URGENT - Field Safety Notice

Hardware update of Patient Support (12NC 989001087431)

FSN MA-FCO 71200185

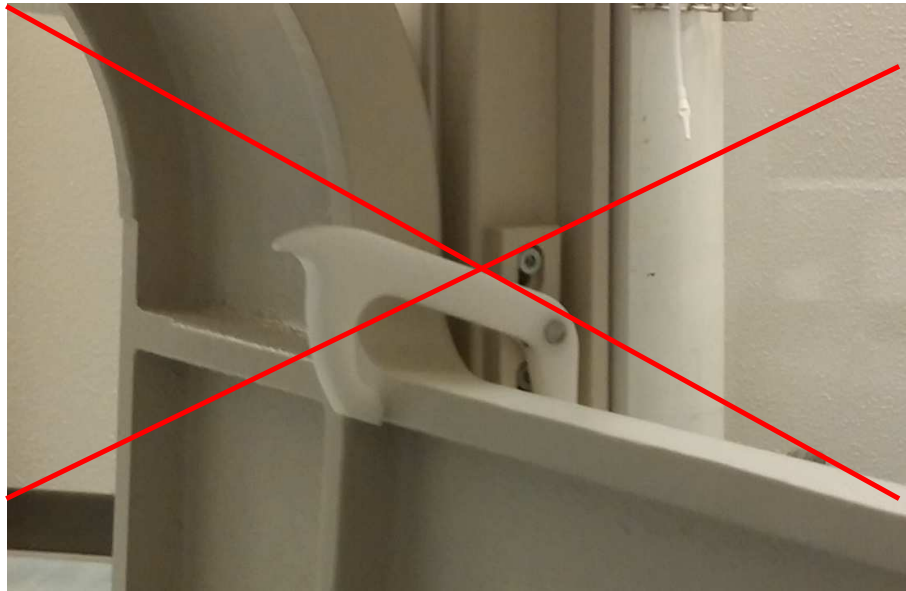
AFFECTED PRODUCTS	Patient support (NC989001087431)
PROBLEM DESCRIPTION	<p>The footplate of the Patient support for stitching can be fixed in upper position. When the fixing clamp (hook) is not in its correct looking position, the footplate is not securely held. If it falls down, it may hurt the operator's or patient's foot or leg (e.g. when moving the stand or when the operator fails to fix it correctly upon moving the footplate up).</p> <p>Following factors are needed that the situation occurs:</p> <ul style="list-style-type: none"> • Hinges are worn differently on both sides • Hook does not hold • Operator does not check that the hook securely holds the footplate • Footplate falls unexpectedly when touched or during transport • Foot or leg in "target area" • Foot in "hazard area"
HAZARD INVOLVED	The hook does not securely hold the footplate in vertical position. Therefore, the footplate can fall or swing down and may hurt the operator or patient.

The customer / user should always check the right position of the hook and that the hook is locked according to IfU. (Press hook down until it is locked) Make sure that the hook is in position as shown in the picture with the green arrow

ACTIONS PLANNED BY PHILIPS	<p>Philips plans to redesign the:</p> <ul style="list-style-type: none">• sturdier replacement hinges for floor plate• install modified hook for floor plate (adapted to new hinges)• brake cylinder below floor plate to minimize kinetic energy <p>A Philips Service Engineer will contact you as soon as the Field Action Kit is ready to be implemented.</p> <p>Should you need to communicate with Philips in regards to this program, please reference FCO-71200185.</p>
FURTHER INFORMATION AND SUPPORT	<p>If you need any further information or support concerning this issue, please contact your local Philips representative:</p> <p>0800 80 3000</p>
